RECREATIONAL AVIATION AUSTRALIA INC

AIRCRAFT AIRWORTHINESS NOTICE

AIRWORTHINESS NOTICE IDENTIFICATION NUMBER : 041207-1

X-Air HANUMAN

BEFORE

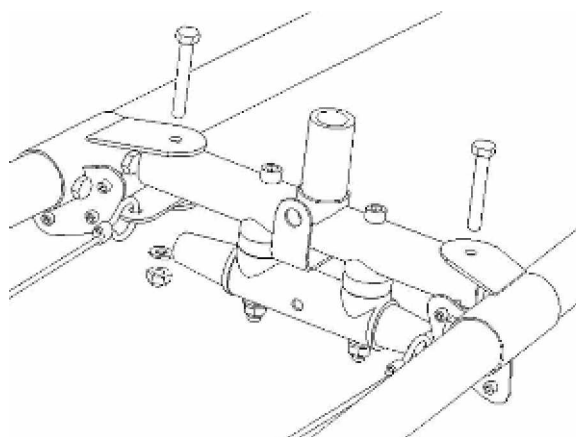
Background: A change in design with regard to the shoulder harness attachment point has been noted through the assembly manual.

Discussion: The previous attachment of the shoulder harness to the cross tube which connects the vertical stabiliser is considered to be less effective than the current design, attaching the shoulder harnesses to the longeron / cross tube joint via separate securing tangs for each harness.

Compliance: Before next flight, owners of X-Air Hanuman's are to check that the shoulder harness is attached in a manner conducive to the latest assembly manual available from the Rand-Kar website or their associated distributor's websites. Register compliance with AN 041207-1 in the aircraft log book.
